Subject: Rapid Depressurization and Decay Heat Removal for System 80™

RESPONSE TO NRC QUESTIONS 13A, 13C AND 13D  
ON RAPID DEPRESSURIZATION AND DECAY HEAT REMOVAL

RESPONSE TO NRC QUESTION NO. 13  
PERMISSIBLE STEAM GENERATOR TUBE THINNING

RESPONSE TO NRC QUESTION 14  
ON RAPID DEPRESSURIZATION AND DECAY HEAT REMOVAL

FIGURE 3.

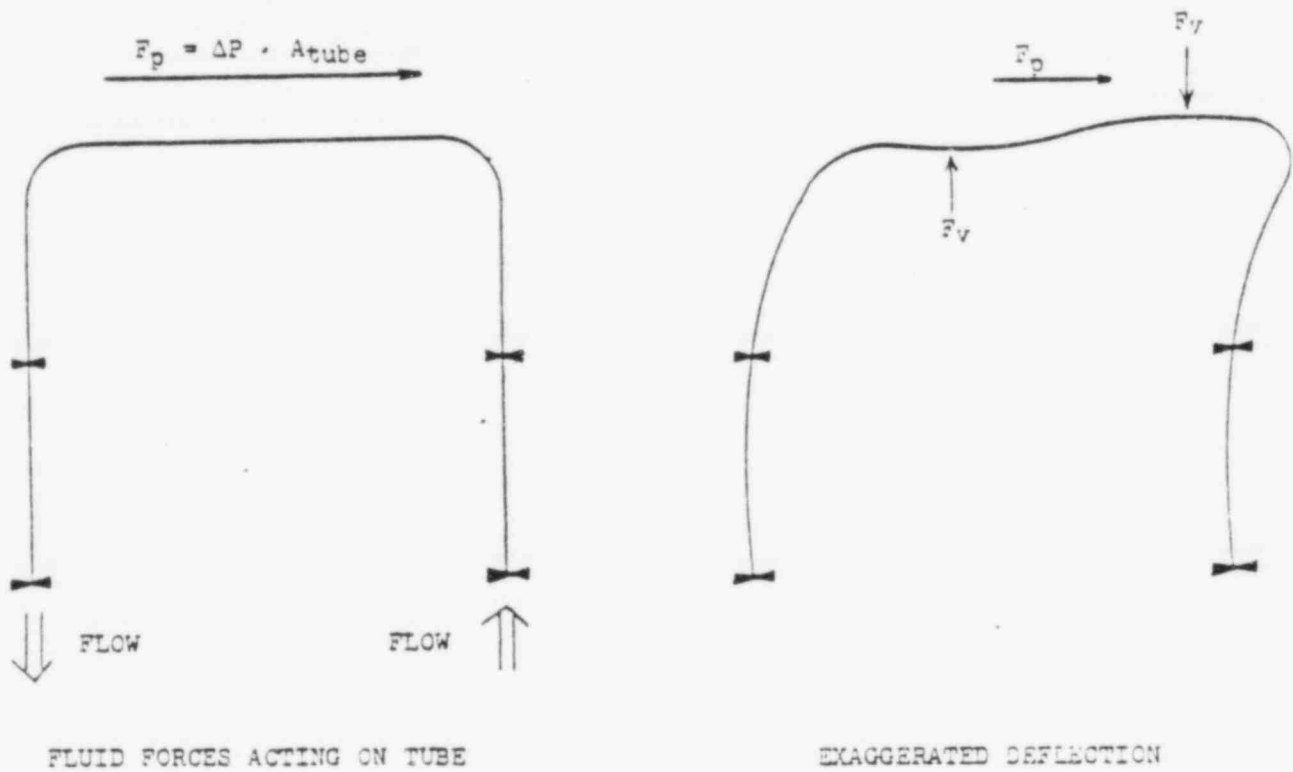
As a result of a postulated LOCA accident a steam generator U-tube will experience an inplane frame type deformation due to the rarefaction wave in the primary coolant which propagates away from the break location (see Figures 2 and 3). This loading, when combined with SSE, LOCA impulse and differential pressure, causes severe bending stress in the tube at its uppermost horizontal support.

(3) An approximate static loading was developed using the figure and equations at the bottom of Figure 3. A stress was developed

$$\sigma_B = \frac{M_p \cdot C}{2I} .$$

This static-stress was compared with the actual stress ( $\sigma_{CALC}$ ) from the structural dynamic "ANSYS" analysis. The ratio of static to dynamic stress was determined and was termed a "magnification factor" (M.F.).

FIGURE 7.

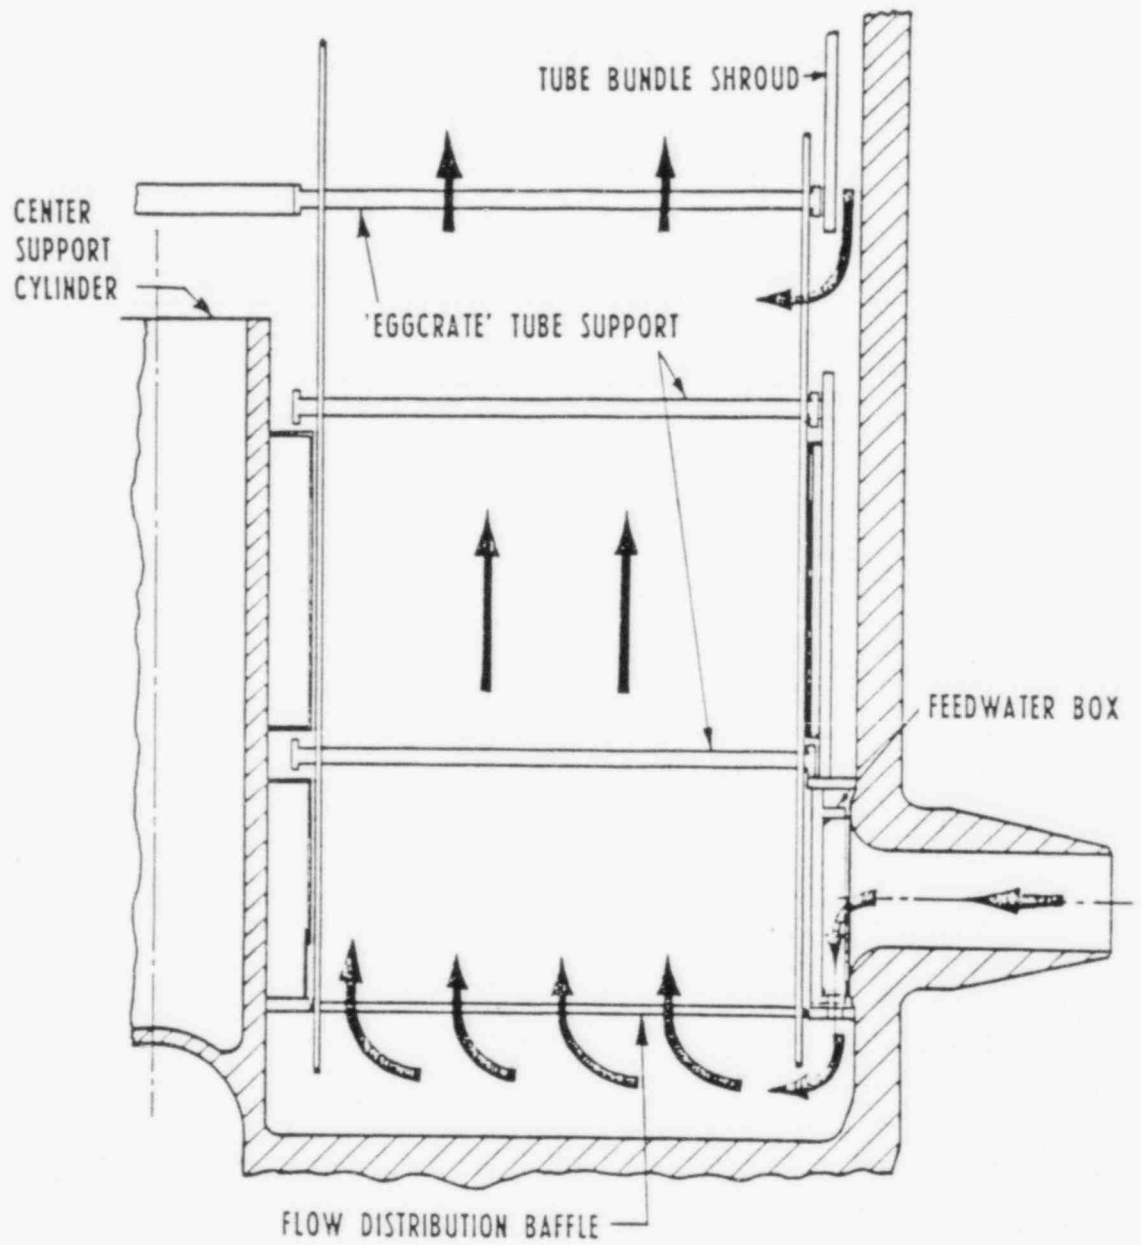
- d. Describe the analytical and experimental justification for establishing a minimum acceptable steam generator tube wall thickness for the C-E System 80 steam generators in accordance with guidelines in Regulatory Guide 1.121, "Bases for Plugging Degraded PWR Steam Generator Tubes". The Justification should include the analyses to calculate the hydraulically induced loading on the steam generator and the thermal response of its tubes and shell to an assumed LOCA, MSLB, and an FWLB.

SUMMARY OF RESULTS - (SEE FIGURE 7)

membrane plus bending stress of 34.2 ksi which is less than the allowable of 1.7 (0.7  $S_u$ ) = 73.5 ksi for the SA-515, GR 70 material. The blowdown duct has maximum membrane plus bending stress of 47.4 ksi and the allowable is 60.9 ksi for the A-500, GR B material.

The membrane plus bending stress intensity at the base of the stay cap assembly is 14.5 ksi which is less than the allowable of 1.38 (0.7  $S_u$ ) = 77.3 ksi for the SA-508, CL 2 material. At the bimetal weld the membrane plus bending stress intensity is 9.4 ksi and the allowable is 67.6 ksi for the SA-516, GR 70 material.

The flow distribution plate has maximum ligament membrane plus bending stress intensity in the perforated region of 49.6 ksi and in the solid rim 34.8 KSI. The allowable for the SA-240, TY 405 material is 1.5 (0.7  $S_u$ ) = 58.7 ksi.

The inner cylinder of the feedwater distribution box has maximum membrane plus bending stress intensity of 38.4 ksi with the allowable for the SA-515, GR 70 material of 1.38 (0.7  $S_u$ ) = 67.6 ksi.

The direct loading of the escaping fluid on the tubes is small ( $\sigma < 1.0$  ksi). The danger to the tubes is that if one of the above four structures fails, it would put the adjacent tubes in jeopardy. However as noted above these structures are very conservatively designed, therefore they will have no impact on thinned tubes.

## ALLOWABLE TUBE DEGRADATION

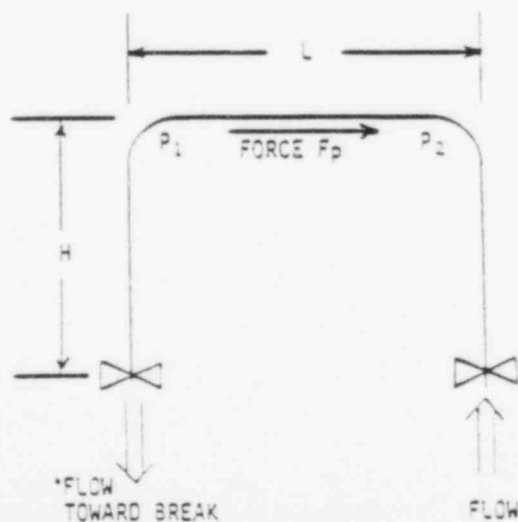
- a. What is the minimum allowable wall thinning that could exist in the steam generator tubes without plugging?
- b. What is the probability that ISI will not detect a degraded tube? Provide the margin of error in eddy current measurements at various depths of degradation.

- c. Given a steam generator with the maximum allowed tube thinning and degradation, confirm that those tubes will maintain their integrity by demonstrating they have been analyzed and shown to remain intact for all design basis loadings used for the steam generator design including seismic loads.

The attached report "Permissible Steam Generator Tube Thinning", shows that 43% tube wall degradation is acceptable at the most limiting tube locations. This value is determined by conservative comparisons to analyses performed on other C-E steam generator designs. The report also presents some tests results that substantiate the validity of the analytical methodology used by C-E to determine tube plugging limits.

- (5) Using the above assumptions and the known parameters from the code stress report and Figure 9, the calc stress ( $\sigma_{\text{CALC}}$ ) was determined. This value was used to determine an estimated permissible tube thinning of 43%.

- (2) System 80 is comparable to plants which have been calculated to possess an allowable tube wall thinning of from 50% to 64%. System 80, allowable tube wall thinning limit is conservatively estimated to be 43%.

FIGURE 1

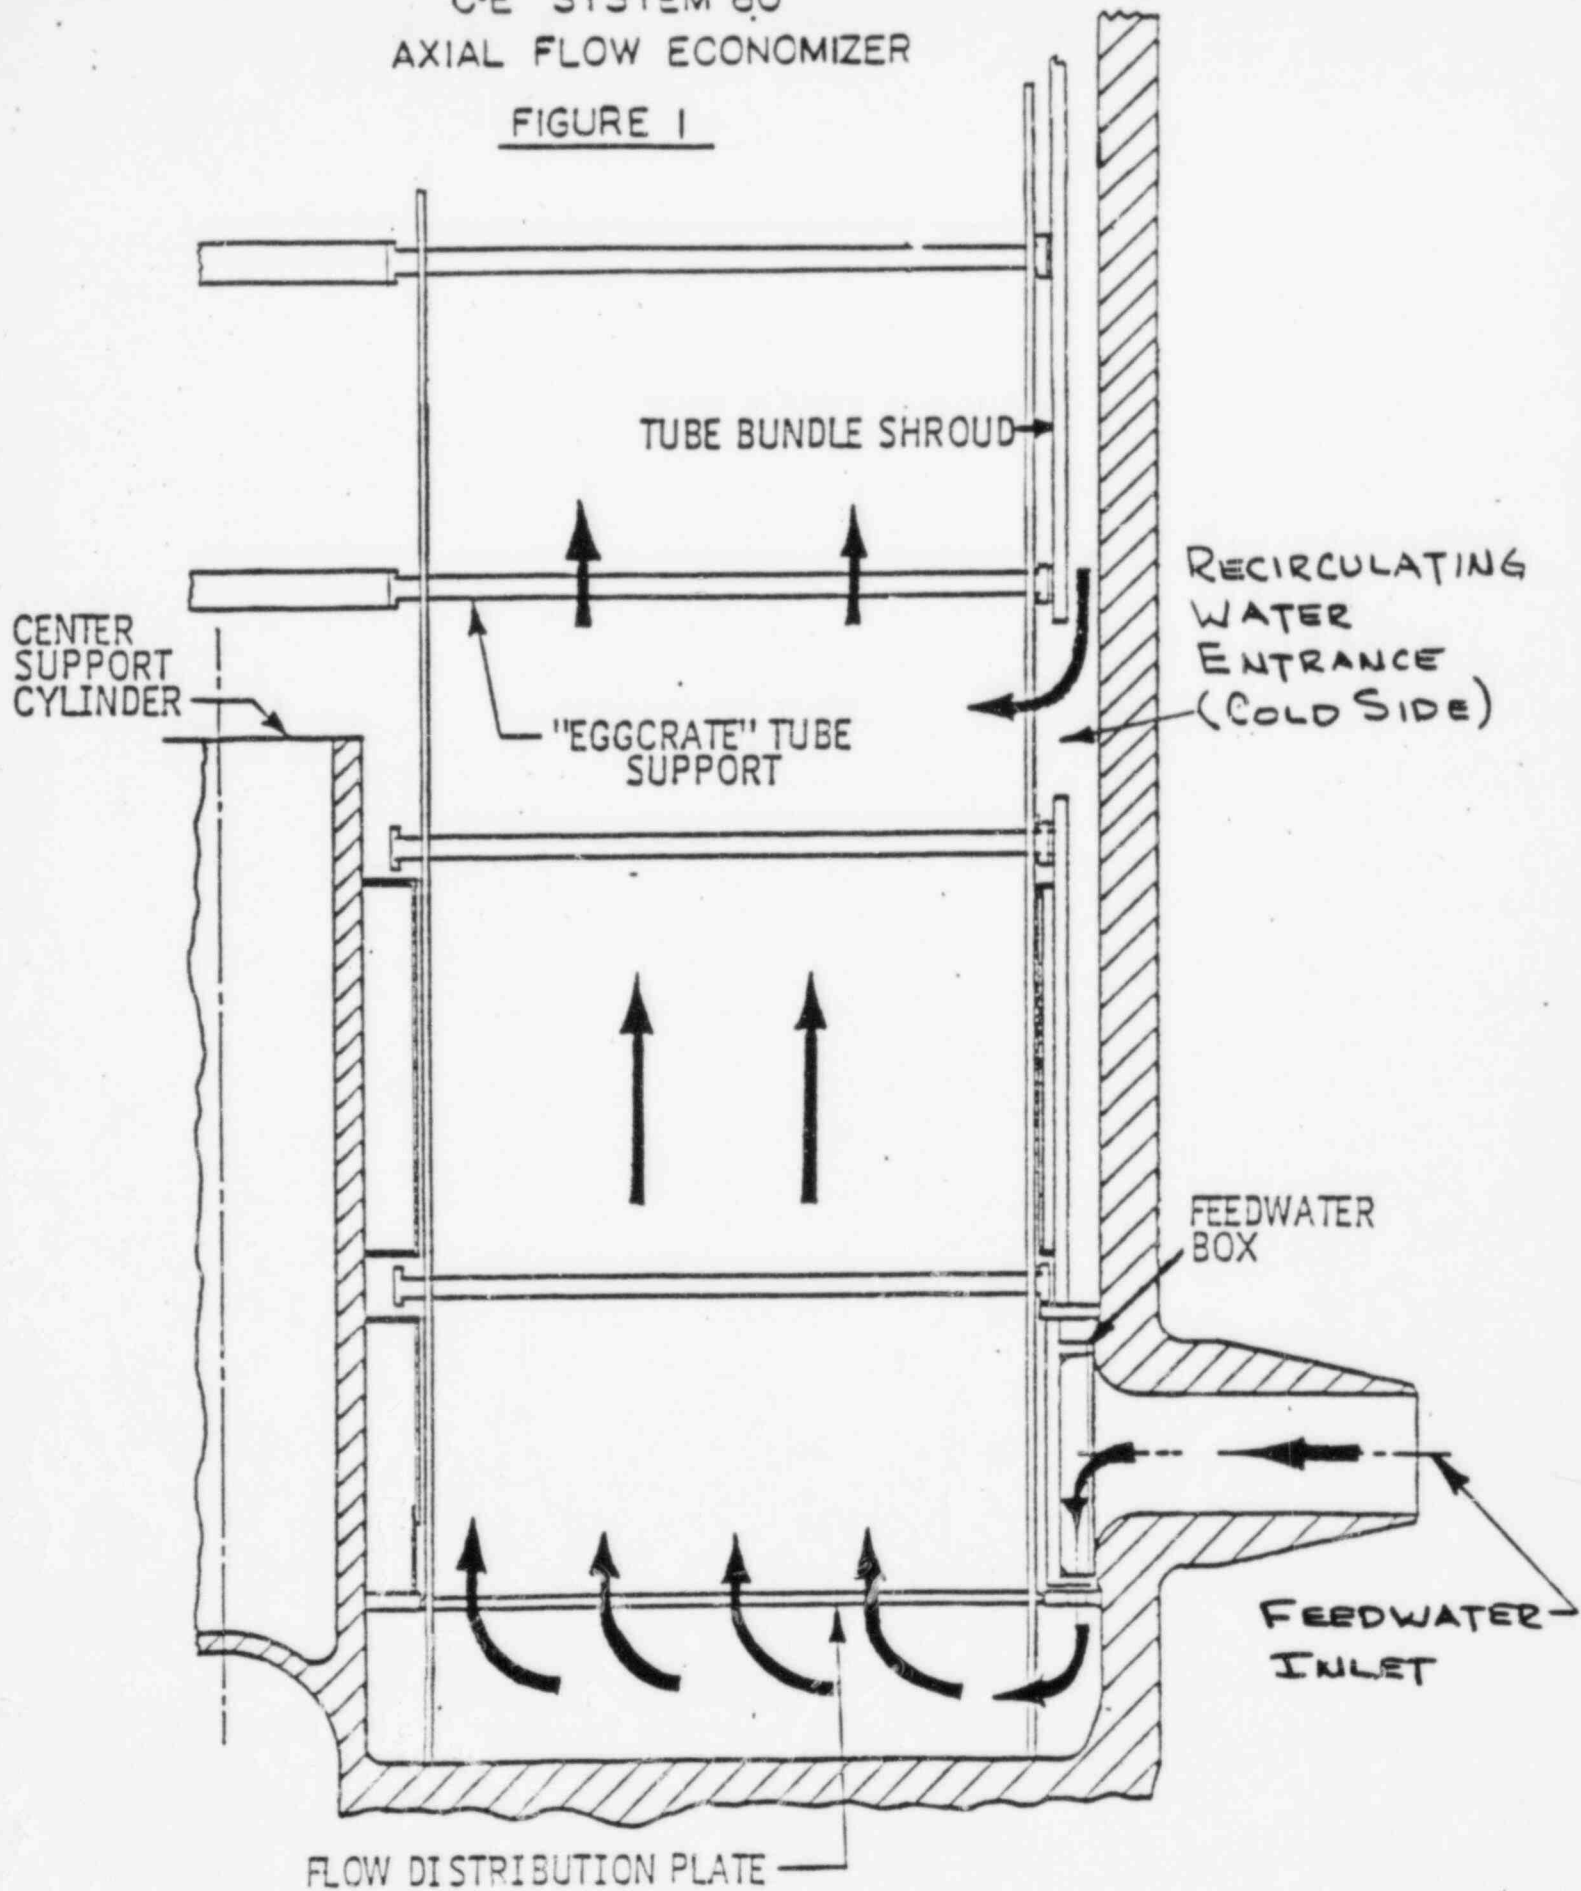
Fretting wear type damage of steam generator tubes in the vicinity of the feedwater inlet has been observed in certain preheat type steam generators of design similar to the C-E System 80™ steam generators. This damage is attributed to flow induced vibrations originating in the economizer of the steam generator. Provide a description of vibration analyses and model flow testing performed during the design of the C-E System 80 steam generators to assure that no damaging flow induced vibrations would occur in these steam generators.

In the C-E axial flow economizer, the feedwater entrance flow is directed down toward the tubesheet by the feedwater box and then upward through the flow distribution baffle. The feedwater entering the economizer is then moving parallel with the economizer tubes (see Figure 1). In addition, recirculating water in the System 80 steam generator cold side enters just above the economizer section. In the economizer design which exhibited tube wear problems (Ringhals), the feedwater entrance flow passes through two perforated plates with non-aligned holes and impinges directly against (perpendicular to) the outermost tubes. Thus, the tube wear problems which occurred at Ringhals cannot occur in the region of the System 80 steam generator economizer entrance. As shown in Figure 1, recirculating water in the System 80 steam generator enters just above the economizer section.

In order to confirm the acceptability of the System 80 economizer, a full scale flow test was conducted. This report, "Supplementary Information for Appendix A - Capabilities for Depressurization and Decay Heat Removal Without PORV's", is attached. The results of the test confirmed that the vibration at the feedwater entrance was extremely small and that the highest vibration amplitude was in the area of the cold side recirculating entrance. In the worst case, the tests show that the tubes experience no potentially harmful vibrational motion.
